Plat Committee

Monday, January 10, 2022	5:30 PM	ZOOM ONLY
		Zoom Meeting ID: 907 714 2200

- I.KPB-3853Barabara Heights Subdivision Griffith Addition; KPB File 2021-156
 - 1. MAP Vicinity
 - 2. MAP Aerial Map
 - 3. Plat Prelim KPB 2021-156 Reduced
 - 4. Staff Report Barabara Heights Sub Griffith Addn KPB 2021-156
 - 5. Plat Parent SL 79-6
- 2. <u>KPB-3854</u> Madson Subdivision Tract A & Tract B; KPB File 2021-164

- <u>1. MAP Vicinity</u> 2. MAP Aerial Map
 - 3. Plat Prelim KPB 2021-164 Reduced
 - 4. Staff Report Madson Subdivision Tract A and B KPB 2021-164
 - 5. MAP Contour
 - 6. MAP Land Mgmt Status
 - 7. MAP Section Line Esmt

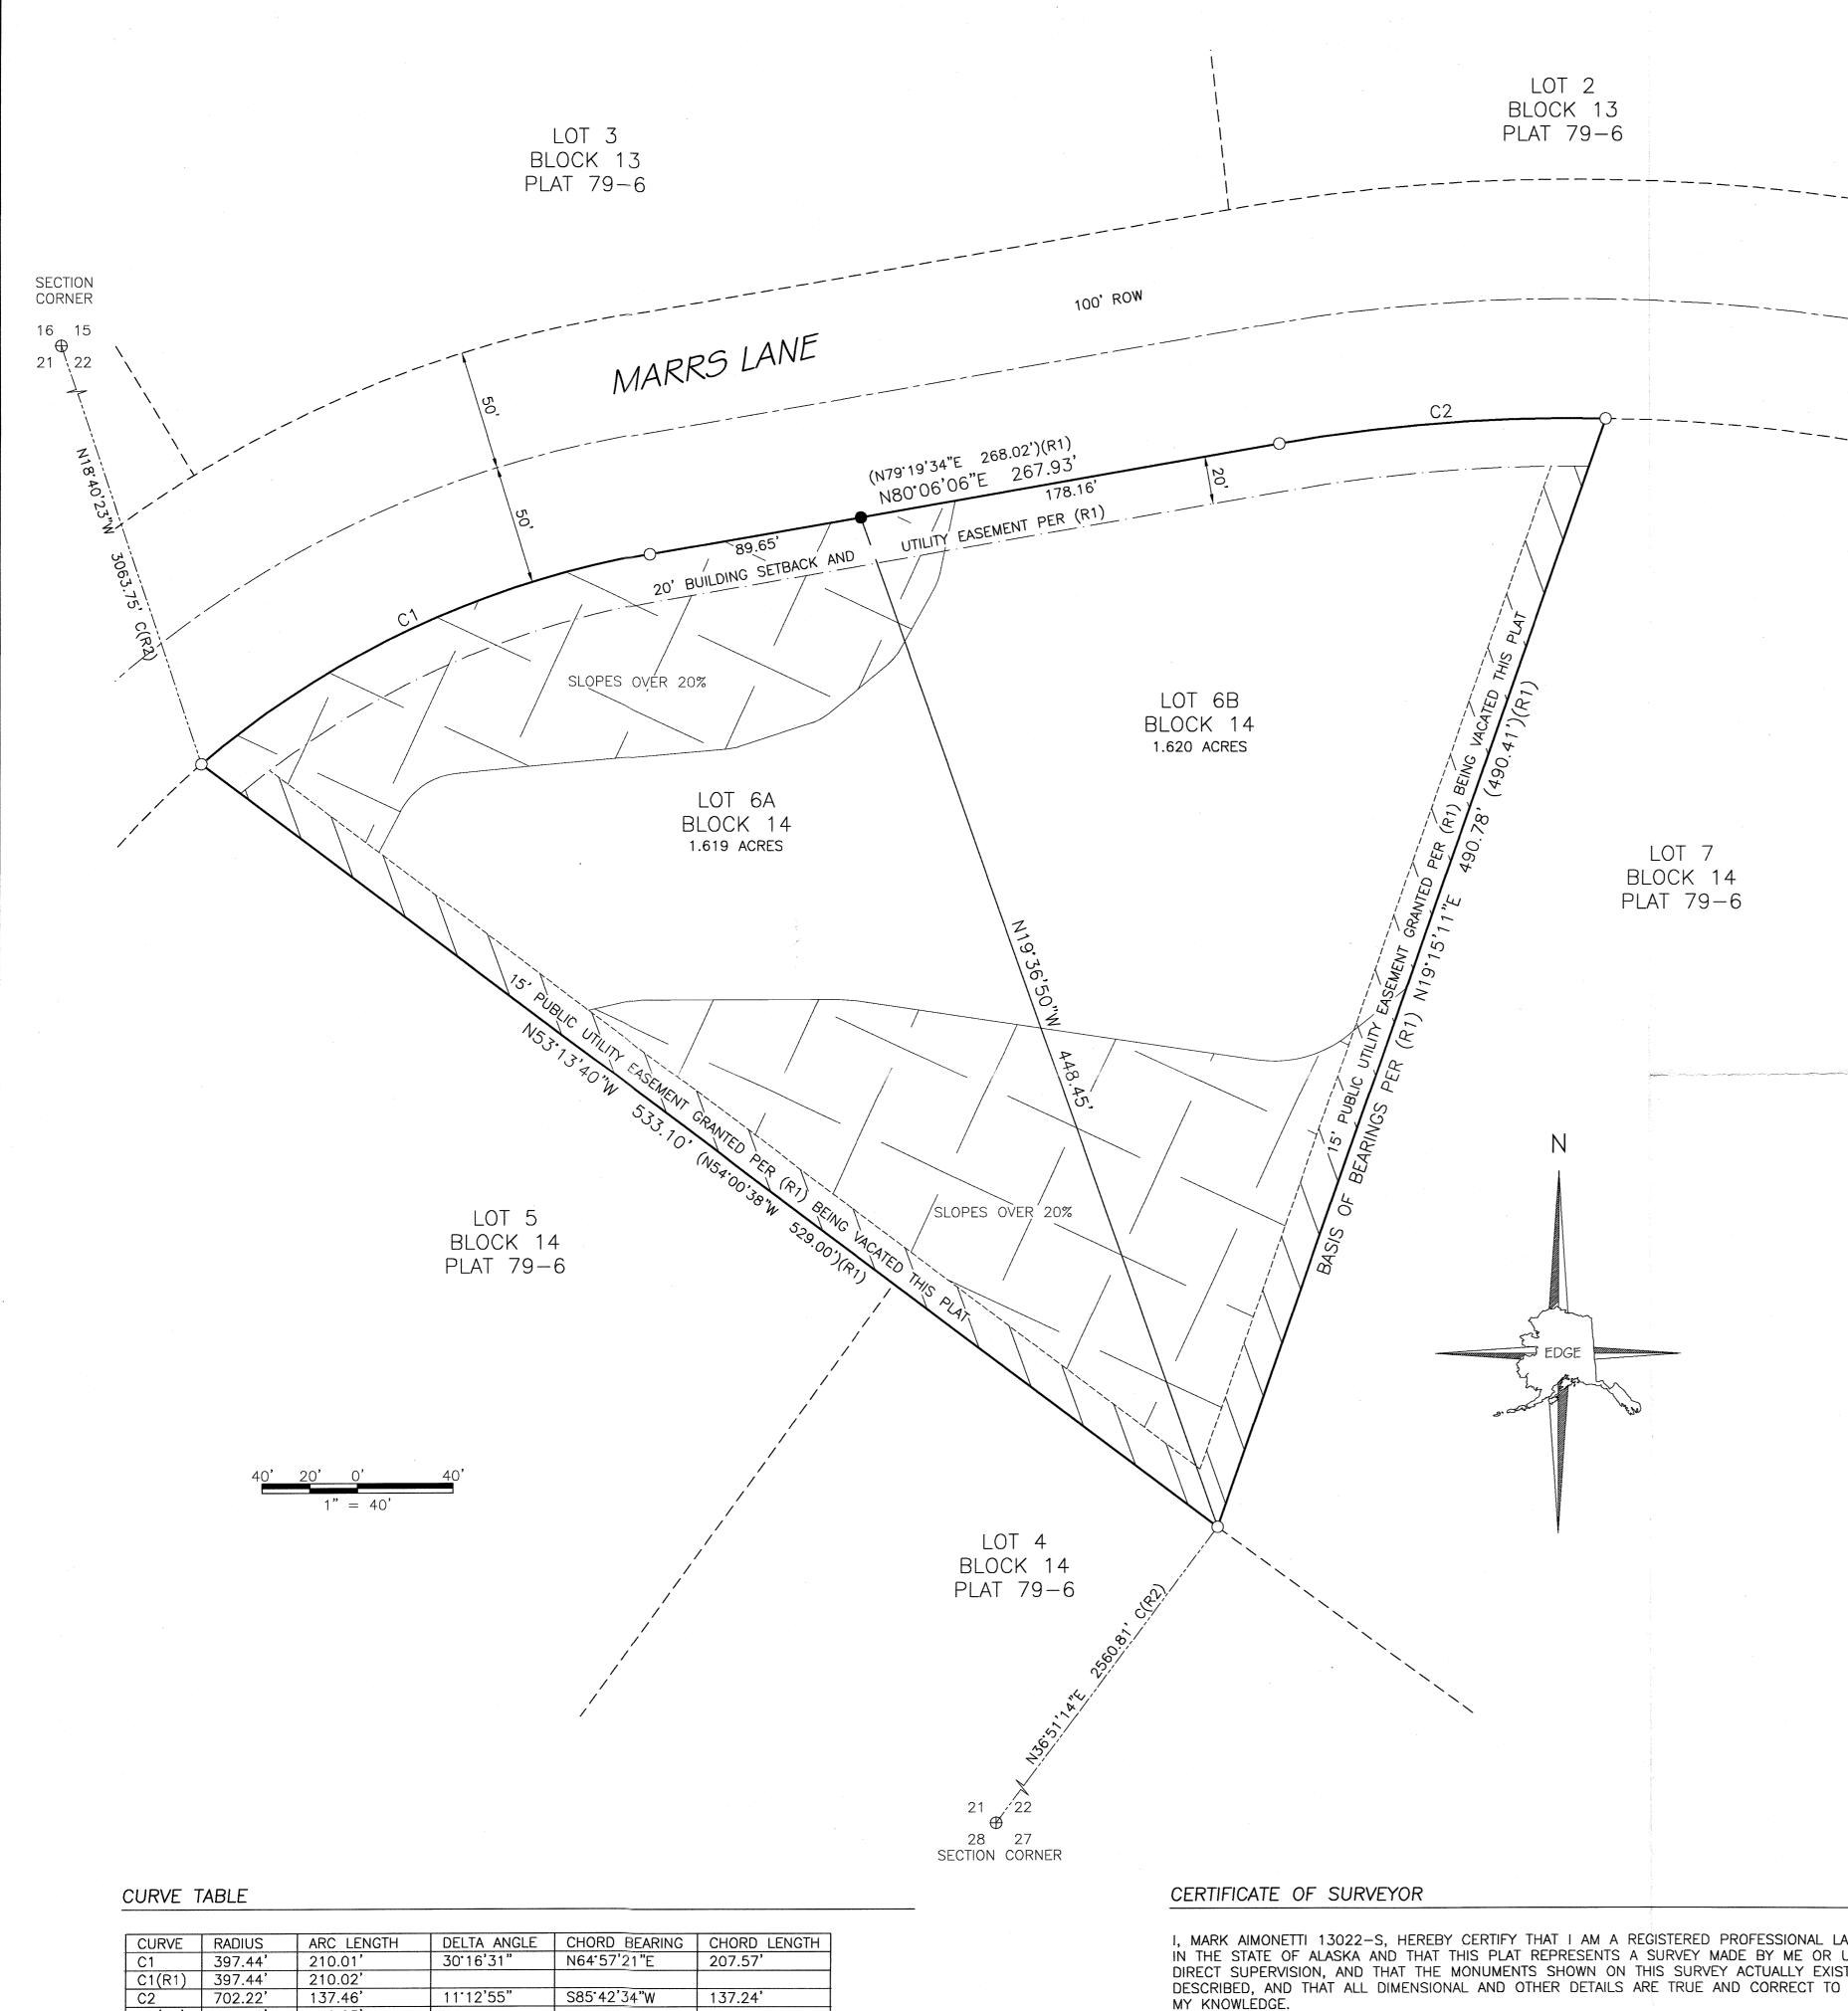
- Update the owners' address to "47580 Sunflower Street".
- Update the acreage as per KPB records and the acreage listed on the lots it should be 3.239.
- Verify the scale used.
- If finalizing the utility easement vacation by the plat, add to the description "and finalizing utility easement vacations".
- D. A vicinity map, drawn to scale showing location of proposed subdivision, north arrow if different from plat orientation, township and range, section lines, roads, political boundaries, and prominent natural and manmade features, such as shorelines or streams;

- Provide a depiction and label for the Seldovia City Limits within Section 32.
- Correct the spelling of the creek name to "Wadsworth".

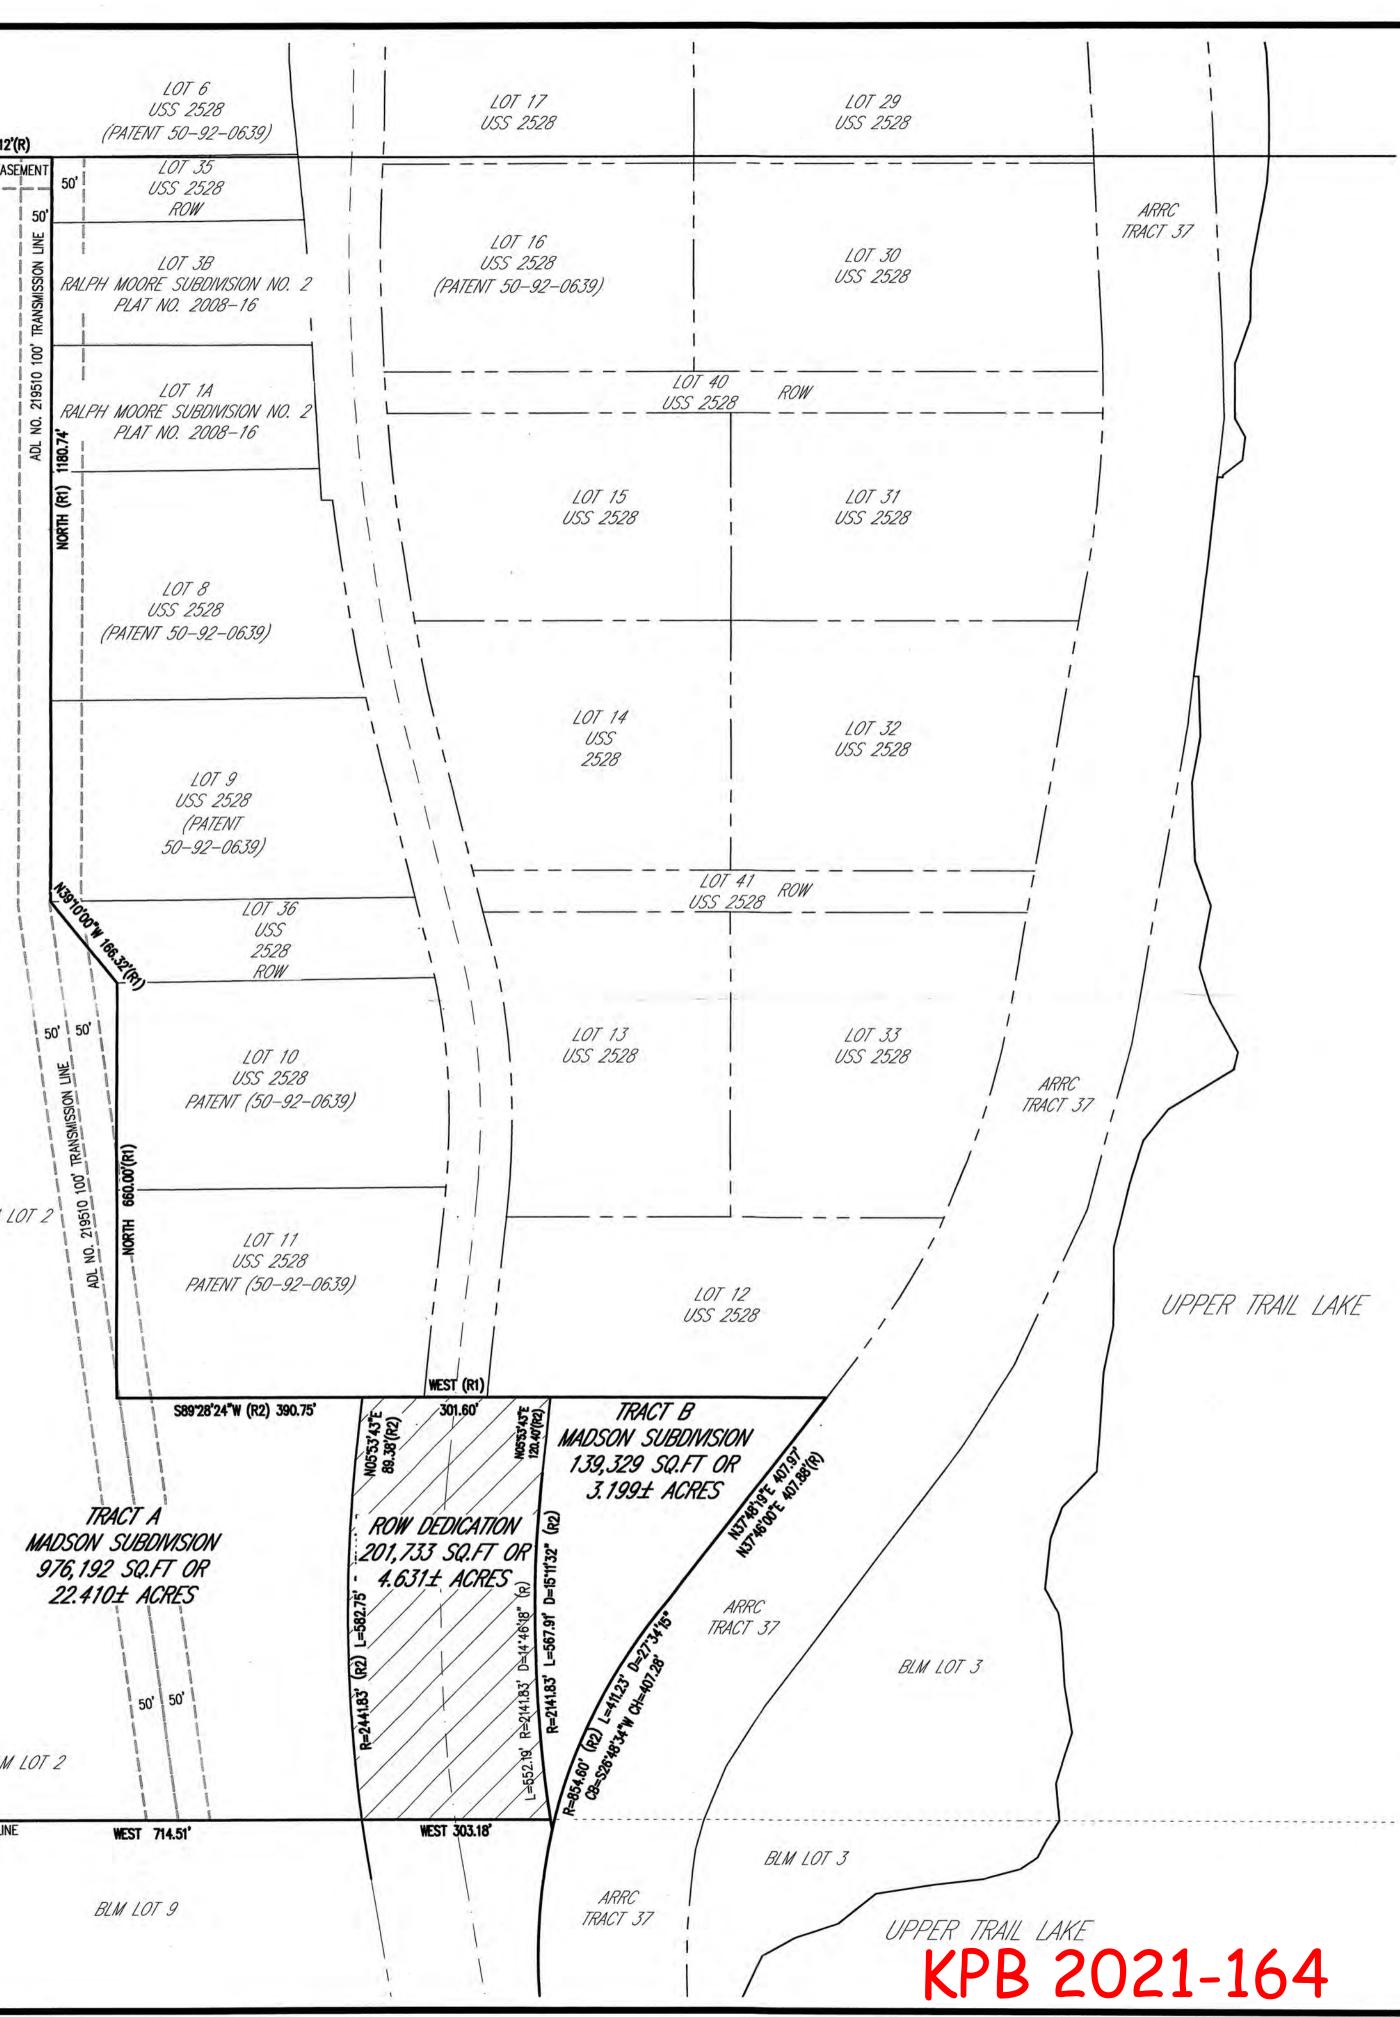
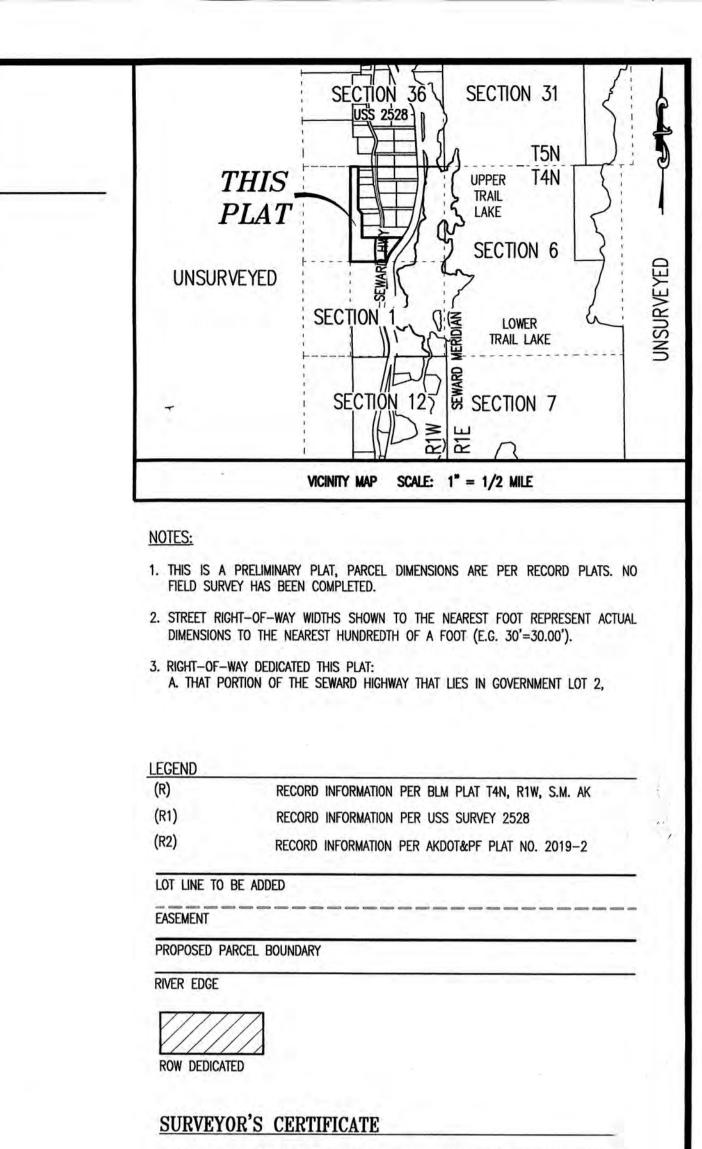
The line labeled river edge is very similar to the lot lines. A different line style should be used to depict the water boundary or the same line style for the adjacent parcels can be used. If a different line style were shown, it would be recommended to change the description to ordinary high water as some may be confused by the fact it is Upper Trail Lake and not a river edge.

Remove the +/- symbols from the acreage values.

- Add the KPB number in or near the title block
- Revise the name of the subdivision by removing Tract A & Tract B so that the subdivision name is
 only Madson Subdivision. If you wish for Tract A and Tract B to be shown in the title block it would
 be suggested to have the name of the subdivision larger include "Creating Tract A and Tract B"
 with smaller font size.
- Revise the description of the subdivision to match the certificate to plat "A subdivision of Government Lot 2 in Section 1, Township 4 North, Range 1 West, Seward Meridian."
- Remove "more or less" from the acreage on the final plat as the acreage will be known after the field survey is completed.
- Provide the owners name and address within the title block.

Staff recommendation: Provide a label for the Seward Highway and a width label for the northern portion or a "width varies" label.

- Remove the "Unsurveyed" labels.
- Provide leaders for the lake labels.
- Provide a label and boundary for the Chugach National Forest.
- Remove the overstrike on the Seward Highway label.

- Provide the protracted section lines in the areas labeled as 'unsubdivided'.
- Provide a label for Grant Lake.

- Provide a label for Government Lot 8 to the north of the subdivision.
- BLM may be removed from adjacent lot labels and changed to Government.
- One label for Government Lot 3 along Upper Trail Lake is all that is required.
- The Kenai Peninsula Borough does not designate the Alaska Railroad as a Tract in this area. Revise the label for the rail road right of way to read 'Alaska Rail Road'
- Remove the patent numbers from the lots.
- H. Approximate locations of low wet areas, areas subject to inundation, areas subject to flooding or storm water overflow, and the line of ordinary high water. This information may be provided on an additional sheet if showing these areas causes the preliminary plat to appear cluttered and/or difficult to read;

Staff recommendation: Provide a depiction and label for the 20 foot building setback adjoining all right of way dedications.

Staff recommendation: Locate the necessary survey markers to establish the subdivision boundary following the procedures as outlined in the BLM Manual of Survey Instructions. Revise the depiction of the boundary. The boundary must include all lands within the subdivision including the right of way and must be more wider then the other lot boundary line depictions.
